仕様変更のご案内

Φ30 TWN/TWND シリーズ コントロールユニット

Φ30 TWN/TWND シリーズコントロールユニットの仕様変更についてご案内いたします。

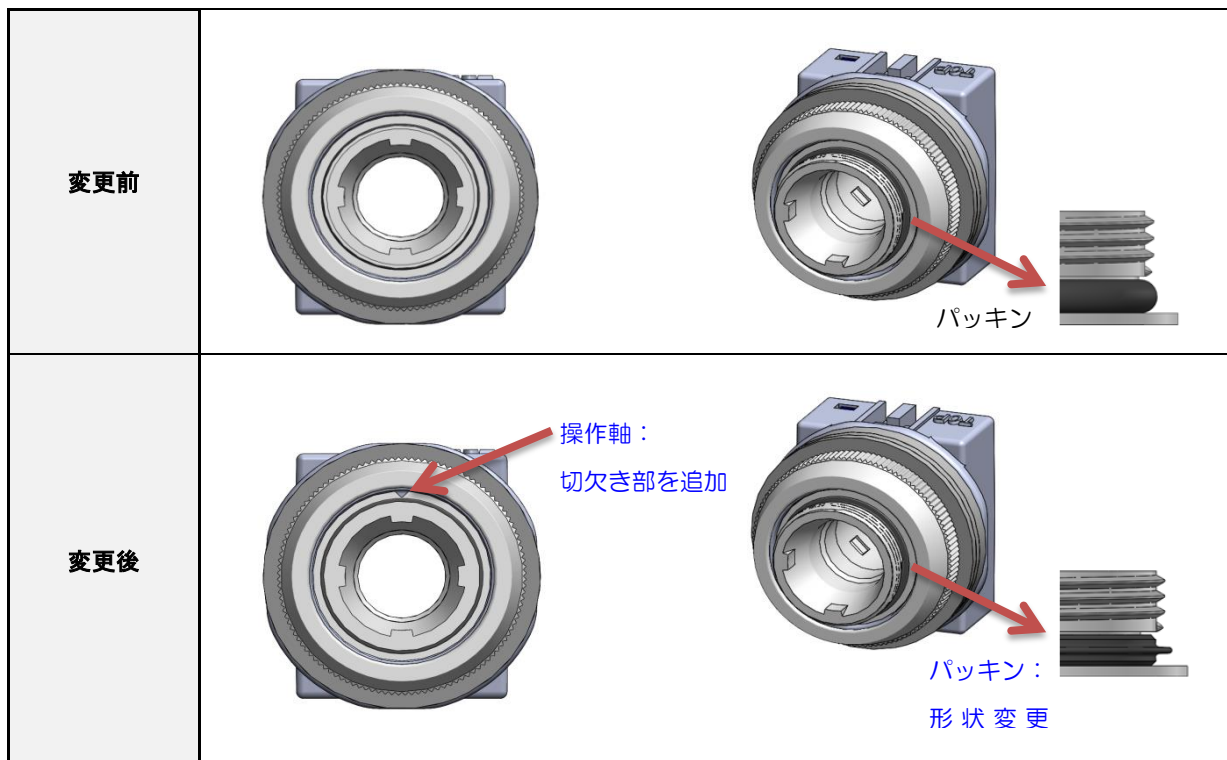
生産性向上のため、ボタン、レンズを外した場合に見えるパッキン、操作軸の形状を変更いたします。

変更後の製品については、梱包ケースの形番表示近傍にドットを記載します。
